# Difference description

Model No.(EUT):T8

FCC ID: 2AUOUT8

Material change list :

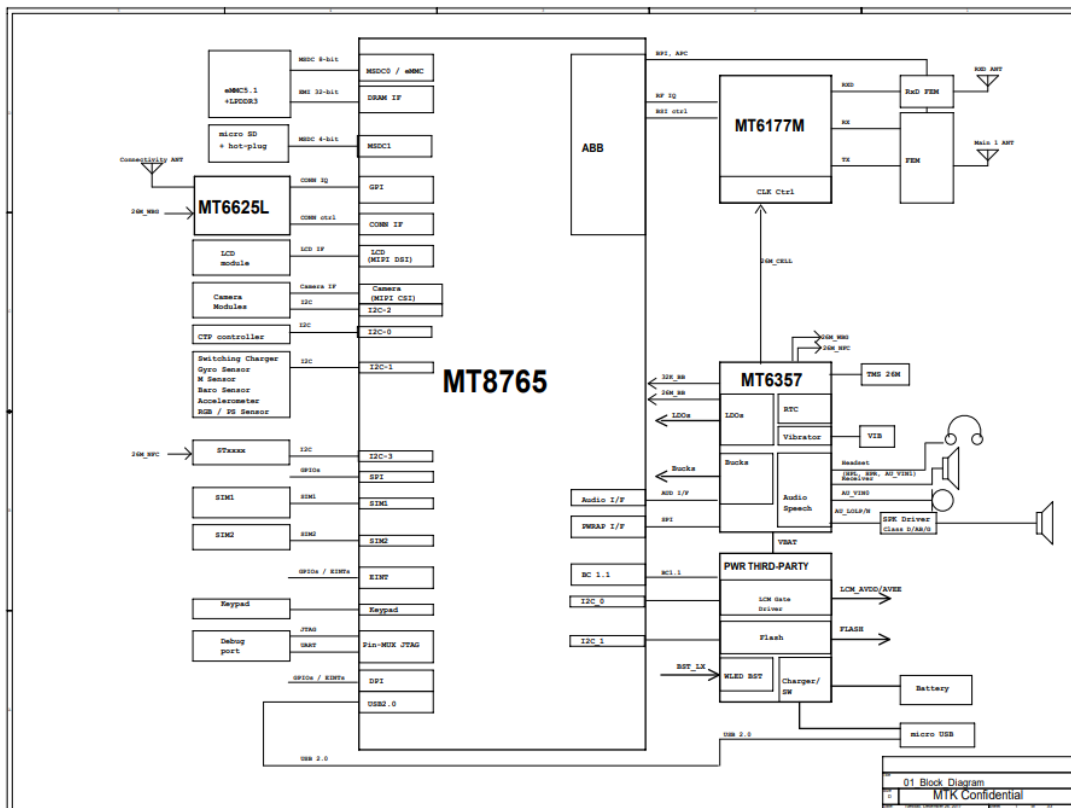
Change request					
Involved to change the model	AS8E2H2WH2FF90HD8091000, AS8E2H2WH2FF90HD8091002	Before the change	U5003=YL19-012109-0001/RFTIP2109BTM5T62/Triplexer for GPS&WIFI(2.4G/1.57G/5G)	After the change	The replacement material is: U5003=YL19-01450G-0001/SLFT21-2R450G-027/Triplexer for GPS&WIFI (2.4G/1.57G/5G) The
			U3418=YL20-008680-0001/MXD8680/SP8T		replacement material is: U3418=YL20-001618-0002/VC1618A/SP8T Switch
			U3916=YL20-007916-0006/VC7916-51/GSM/GPRS/EDGE /TD-SCDMA/TD-LTE 4-segment RF power amplifier and 16T antenna switch Encapsulation QFN38 5.5mmX5.3mmX0.83mm		U3916=YL20- 007916-0008/VC7916-51-1/GSM/GPRS/EDGE/TD-SCDMA/TD-LTE 4-segment RF power amplifier and 16T antenna switch Encapsulation QFN38 5.5mmX5.3mmX0.83mm
			U4201=YL20-0432G0-0038/MEMA032G-M0S00/EMMC, 5.1, 32GB, TLC, 11.5mm x 13mm x 1mm, BGA153		U4201=YL20-04F32G-0003/MEMA032G-MOD01/EMMC, 5.1HS400, 32GB, TLC, 1.8/3.2V, BGA153

1.U3916=VC7916-51 main function: GSM/GPRS/EDGE RF power amplifier and 16T antenna switch

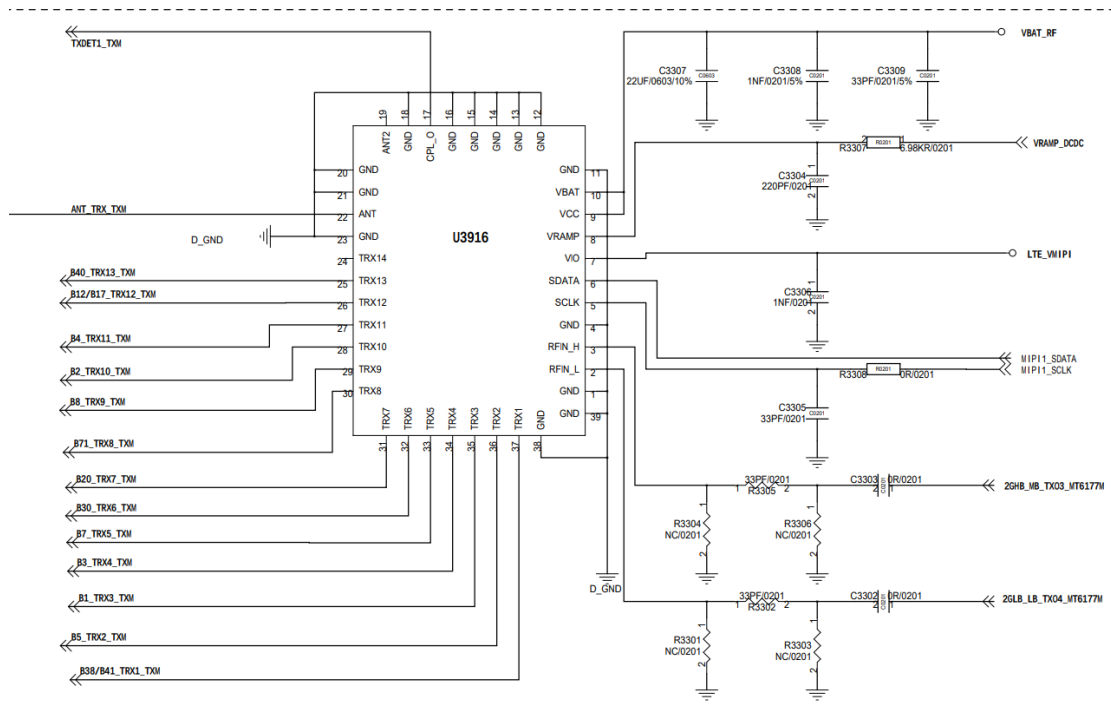
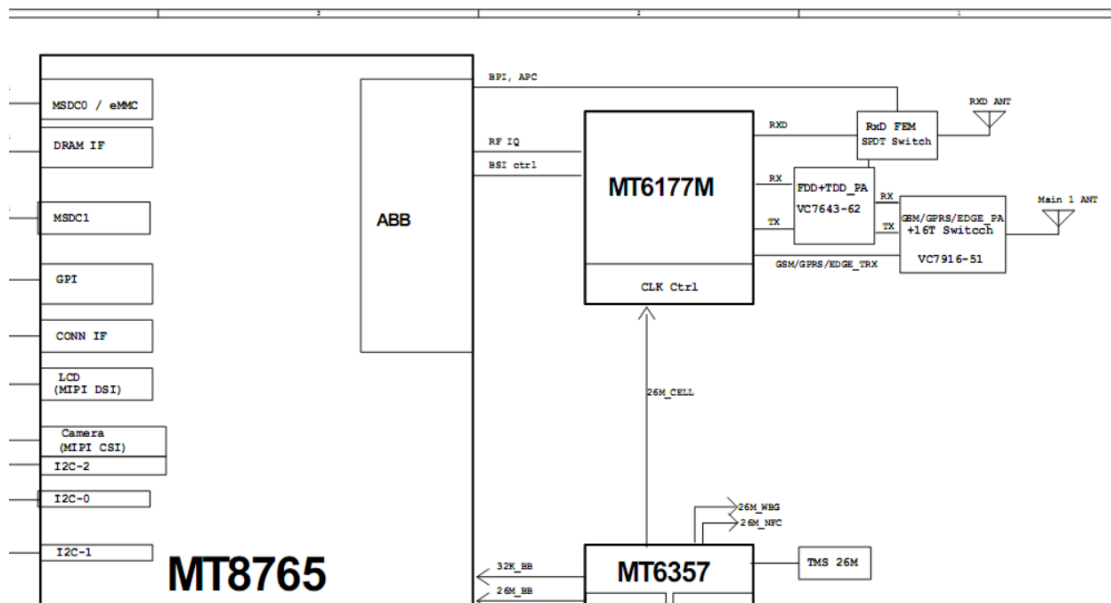
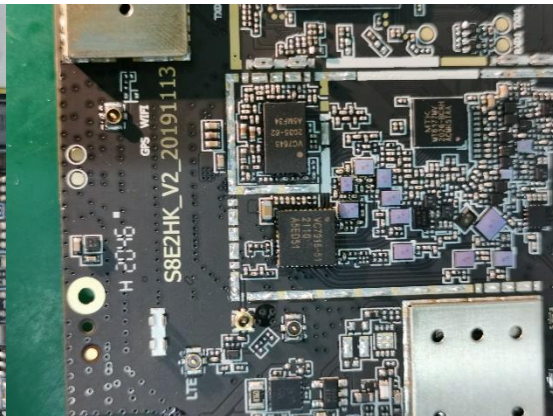
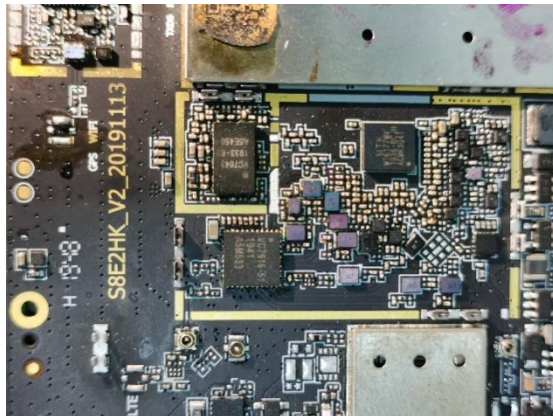
**Different batches of PA (VC7916-51) have been replaced.**

**Different batches refer to substrates supplied by different substrate suppliers at different times, and PA produced and processed by different processing plants. There are no other differences.**

The PA PIN before replacement is the same as the PA PIN after replacement, there is no change.

2, U3916=SLFT21-2R450G-02T Triplexer for GPS&WIFI (2.4G/1.57G/5G) Main function: 2.4G/1.57G/5G power splitter

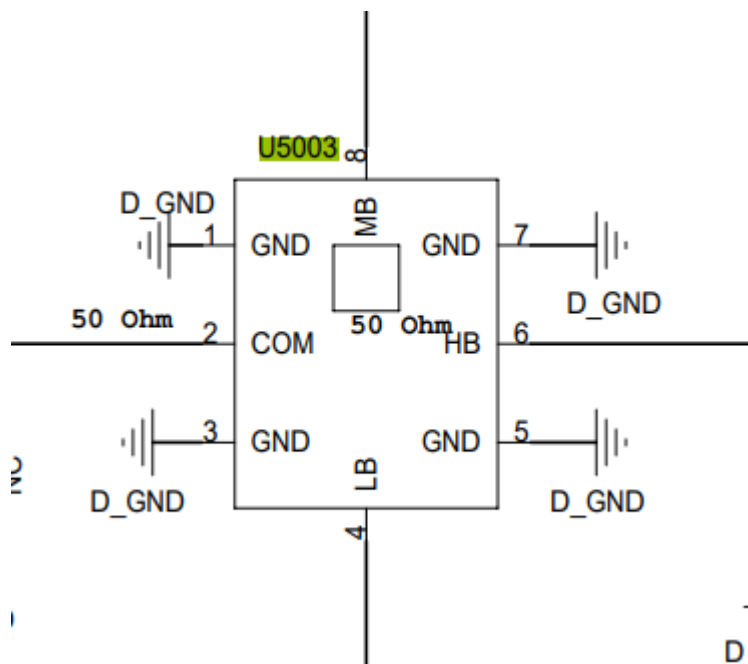
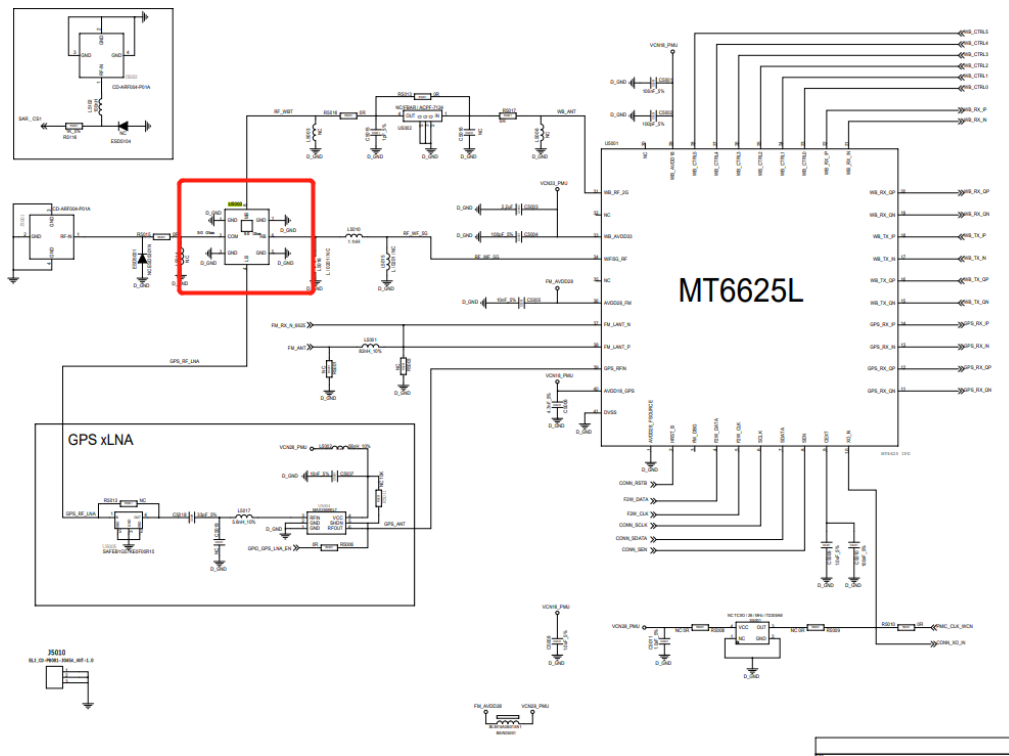
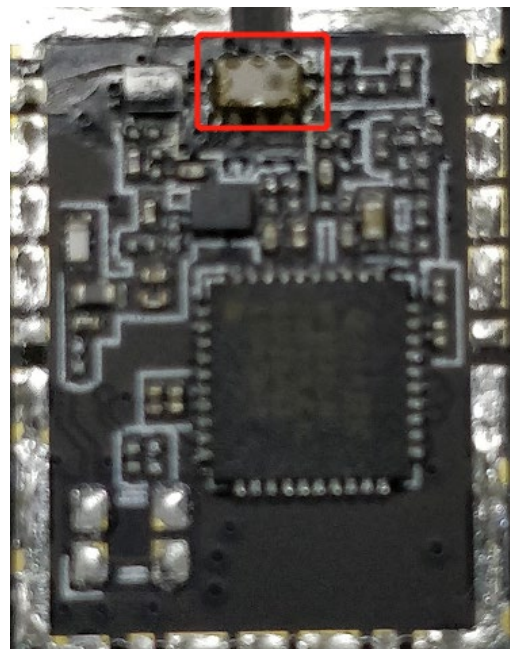
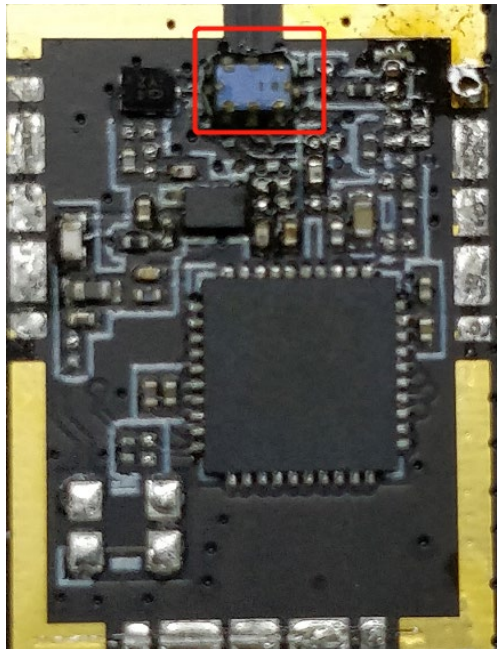
**Due to market supply, the purchase of different batches refers to the power dividers produced and processed by different processing plants at different times, supplied by different suppliers. There are no other differences.**

The PA PIN before replacement is the same as the PA PIN after replacement, there is no change

3. U3418=VC1618A SP8T Switch main function: WCDMA/LTE diversity receiving antenna switch

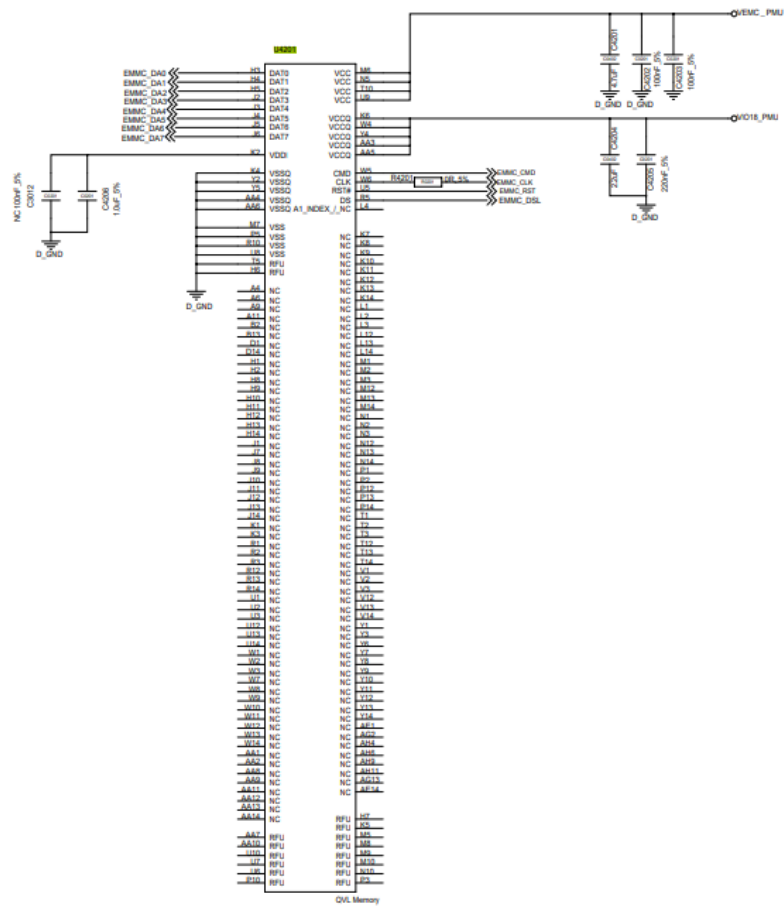
**Due to market supply, different batches of purchase refer to products supplied by different suppliers at different times, and produced and processed by different processing plants. There**
